**SONGS-1 APPROACH
TO
INELASTIC BEAMS**

**Southern California Edison Company
P.O. Box 800
Rosemead, California 91770**

**Impell Corporation
350 Lennon Lane
Walnut Creek, California 94598**

QUESTIONS ON SONGS 1 APPROACH TO INELASTIC BEAMS

Figure 6

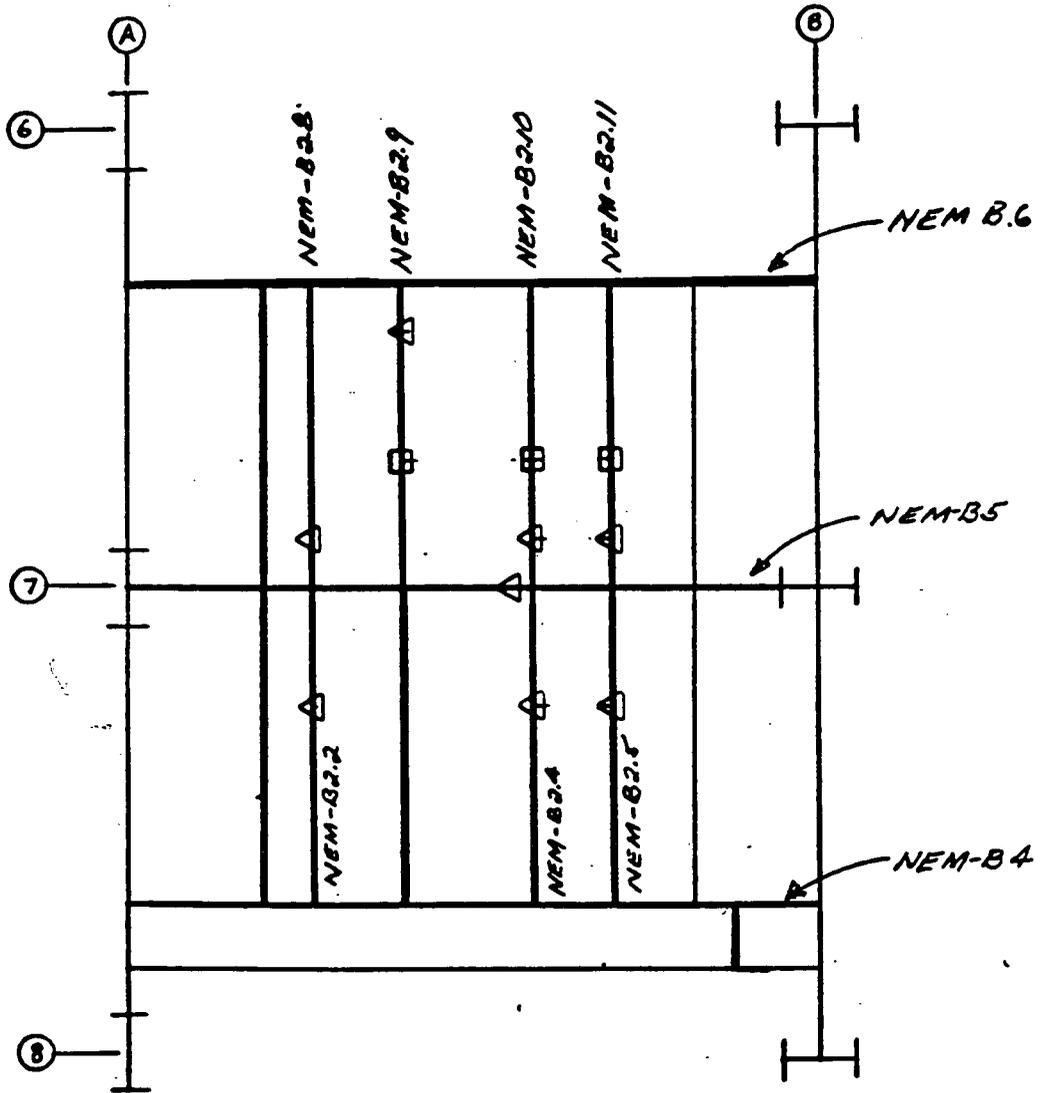
- 8) (3.1) - Will an inelastic beam with two attached pipe supports, each from a different piping system, be considered isolated (example - NEM-B2.9 in Figure 6)?

- 9) (3.1) - Will an inelastic beam which supports multiple inelastic beams with attached pipe support be considered isolated (example NEM-B5 in Figure 6)?
